Subject: Mine Ventilation Plan, Section 75.370, 30 CFR 75, Upper
Big Branch Mine-South, I.D. No. 46-08436, Performance
Coal Company, Montcoal, Raleigh County, West Virginia

This will acknowledge receipt of the ventilation revision dated December 7, 2009,
and received by MSHA on December 8, 2009.

The ventilation revision requests to route a travelable return aircourse from the
active MMU-029 into a common entry with MMU-040; make the #3 headgate
entry a common intake aircourse with the existing primary escapeway; provide
dewatering information; and project a future gateroad.

Face Ventilation Typical
Gateroad Development

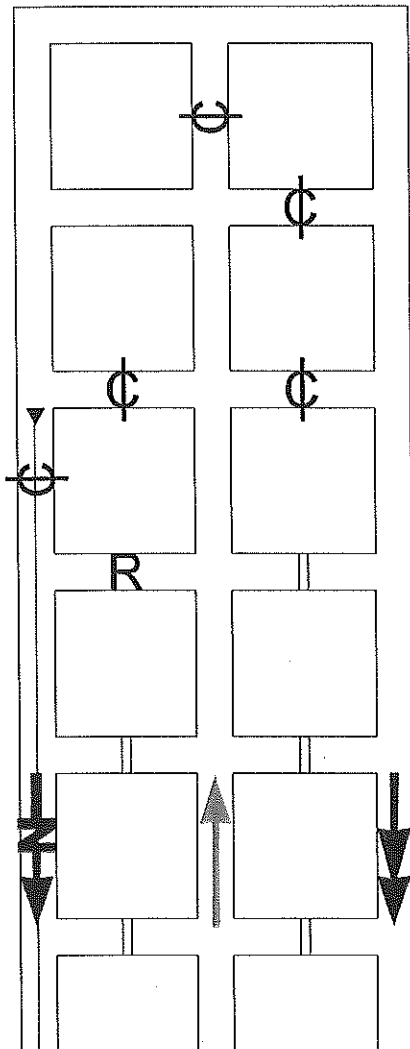
The submittal also does not provide information as to whether the isolated return split will be traveled in by the longwall face, back towards the common entries out by the longwall tailgate EP-LW3, or the specifics regarding the reconstruction of stoppings which separate the number 2 and number 3 entries as shown on the face sketch.
